Request for Quotation

RFQ NUMBER
 DEFK7044

ADDENDUM # 2

PROJECT: KINGWOOD READINESS CENTER
Camp Dawson
Kingwood, West Virginia

SHEET NUMBER:
SD-C-001

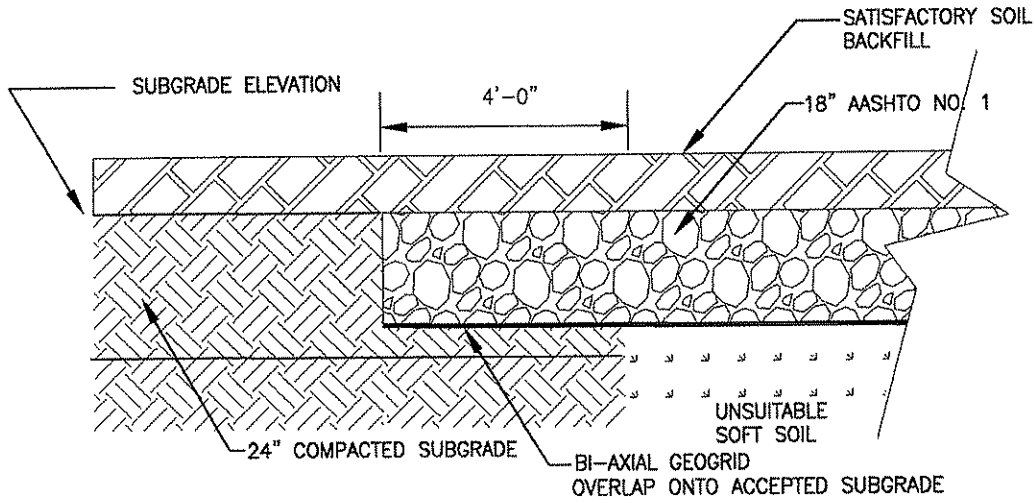
ADD THE FOLLOWING 8 ½ X 11 DETAIL:

SD-C-001 Over-excavation Detail

- E. Over-excavation will be used to "bridge" soft areas of unsuitable soils. The soft area and an additional 48" around it will be excavated 18" below subgrade and the material hauled to the waste area for disposal. A biaxial geogrid will be installed per the manufacturers guidelines and backfilled with 18" of AASHTO No. 1 stone. The stone will then be rolled to lock it in place. Any damage to the geogrid during installation will be removed and replaced at the contractor's expense.
